**STATE OF MAINE**  
**DEPARTMENT OF ENVIRONMENTAL PROTECTION**  
**BUREAU OF REMEDIATION AND WASTE MANAGEMENT**  
**DIVISION OF TECHNICAL SERVICES**  
**M E M O R A N D U M**

TO: Linda Butler, Project Manager  
FROM: Gail Lipfert, PhD, C.G. # GE506 Hydrogeologist  
DATE: June 22, 2020  
RE: Response to Comments on Phase 14 Solid Waste Permit Application, Volume III,  
Crossroads Landfill, Waste Management Disposal Services of Maine (WMDSM),  
Norridgewock, Maine  
CC: Chris Evans, C.G., Hydrogeology Unit supervisor, Kathy Tarbuck, P.E., Project Engineer

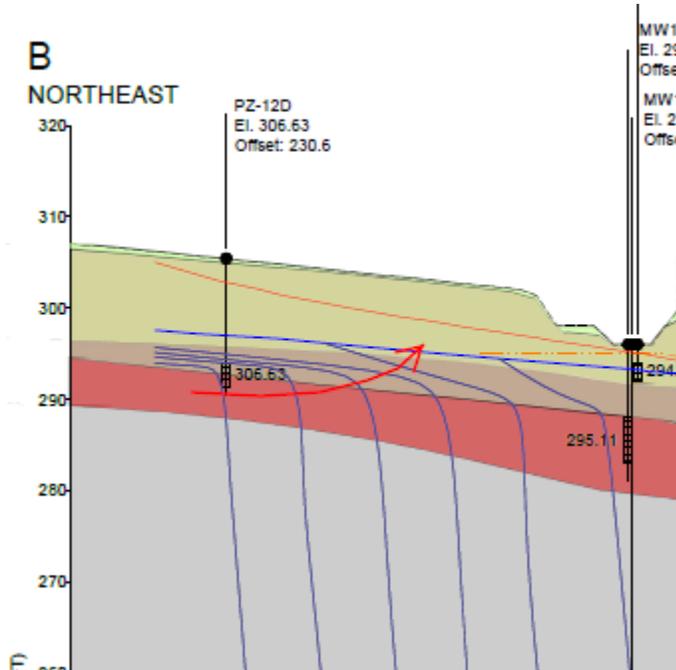
- They claim that they did not find vertical fractures in this investigation, but in the 1992 investigation of neighboring and contiguous clay units, every test pit and almost every boring showed vertical and horizontal fissures, vesicles, sandy layers and seams. In a paper for the 2015 Symposium on the Presumpscot Formation in

Portland Maine, Luettich et al. ([https://umaine.edu/presumpscot-symposium/wp-content/uploads/sites/425/2015/10/Luettich\\_etal\\_2015\\_Presumpscot.pdf](https://umaine.edu/presumpscot-symposium/wp-content/uploads/sites/425/2015/10/Luettich_etal_2015_Presumpscot.pdf)) describe the upper olive-brown clay unit as exhibiting “a wide range of post-depositional features such as desiccation fissures, disruption by roots, frost fracturing, and expansion fracturing.” The likelihood of intercepting vertical fractures with vertical, 2-inch borings is very small and could explain why they did not encounter fractures.

- Short-term slug tests within units are unlikely to show transport across units. To quote Holland and Tolman (1987), “We believe that conventional cased drilling techniques render even in-situ permeability tests in fissured clay invalid, again because of damage to the secondary structure.” Also, small fractures that would allow the transport of contamination may not
- Laboratory permeameter tests only test bulk properties and the likelihood of encountering a fracture in a small piece of clay is tiny. See our comments above regarding permeameter tests.
- They claim that freeze-thaw fractures would only occur above the water table, which would be in the sand or fill. This may be true, but the fact is that polygonal fissures were described in the stiff clay in every test pit in the 1992 investigation, and, although rare, fractures were described in the gray clay to depths of 15 feet.
